REF: SPR-45-24 DATE: October 10, 2024

Subject			
	Request	-	Major Site Plan Review for a New Parking Lot
	Location	-	3815 W. Sylvania Avenue
	Applicant / Owner	-	Jeff Nowalk, Director of Facilities Lucas County Commissioners One Government Center, Suite 800 Toledo, OH 43604
	Civil Engineer	-	Seth Transue Civil & Environmental Consultants, Inc. 250 W. Old Wilson Bridge Road, Suite 250 Worthington, OH 43085
Site Description			
	Zoning	-	RM36 – Multi-Family Residential & RS6 – Single Dwelling Residential (CO – Office Commercial Pending)
	Area	-	$\pm 2.23$ acres
	Frontage	-	± 300' along Sylvania Avenue ± 330' along Woodley Road
	Existing Use	-	Funeral Home
	Proposed Use	-	Parking
Area Description			
	North	-	RM36 / Apartments
	South	-	CO / Medical Offices
	East	-	RM36, RS9 / Lucas County Shared Services Bldg.
	West	-	CO, RM36, RS9 / Medical Offices, Multi-Unit Dwellings
Parcel History			
	T-177-61	-	Lot Split of the westerly three hundred feet (300') of the original parcel. (Administratively approved 6/21/24)

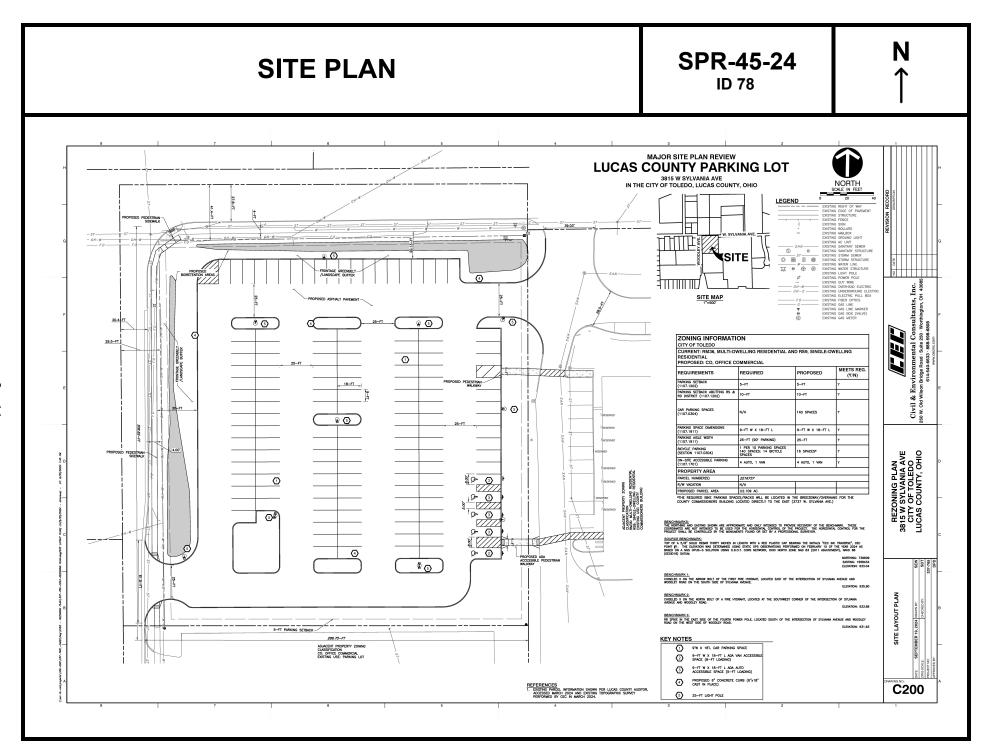
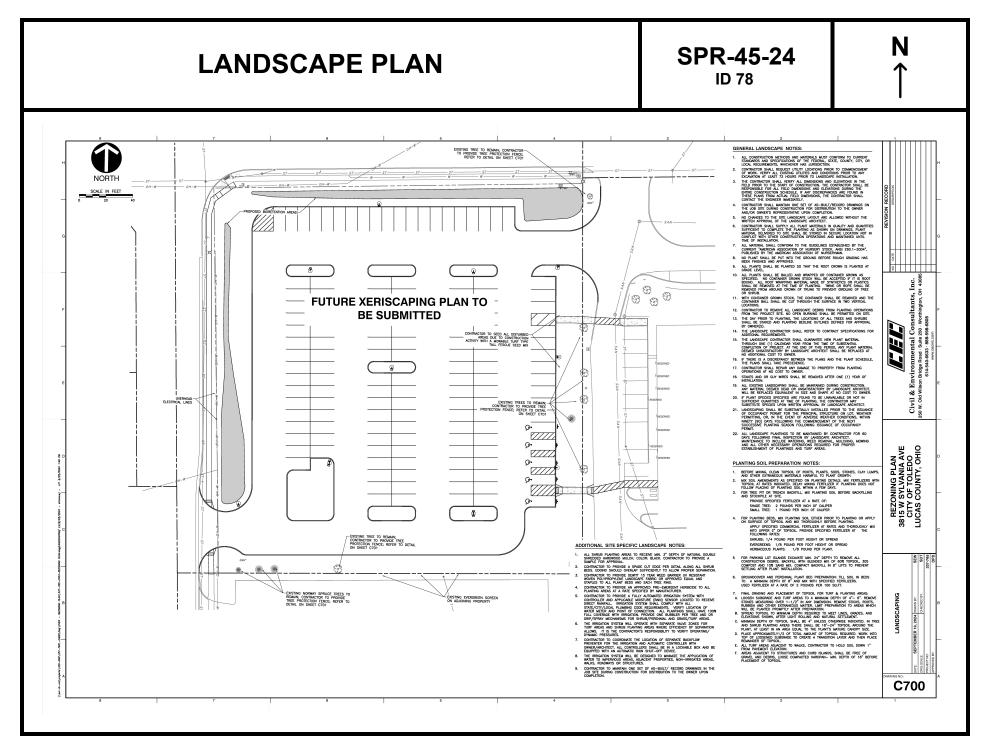
The applicant has proposed two (2) bioretention areas within the frontage greenbelt. Bioretention areas are permitted within the frontage greenbelt; however, they may only occupy up to 50% of the actual available green space. The proposed bioretention area along Sylvania Avenue occupies 41.4% of that frontage greenbelt's greenspace (measured from the right-of-way line to the curb). On the other side, Woodley Road's frontage greenbelt is only 29.8% occupied by its proposed bioretention area. The proposed bioretention area locations are acceptable as depicted. Staff will work alongside the Division of Engineering Services to ensure bioretention areas meet the requirements of bioretention areas as outlined in TMC§1108.0206.

- 4. The existing trees between the two existing driveways by Woodley Road need to be removed for the proposed sidewalk. On sheet C100 it does not show that those trees will be removed.

- 19. Bicycle parking location is required to be clearly shown on drawings per TMC 1107.0900.
- 20. Ground painted accessible parking signage is required to be inside the parking spot and not in the drive aisle.
- 21. Property line must be brought into alignment with right-of-way line of Woodley Road and Sylvania Avenue.
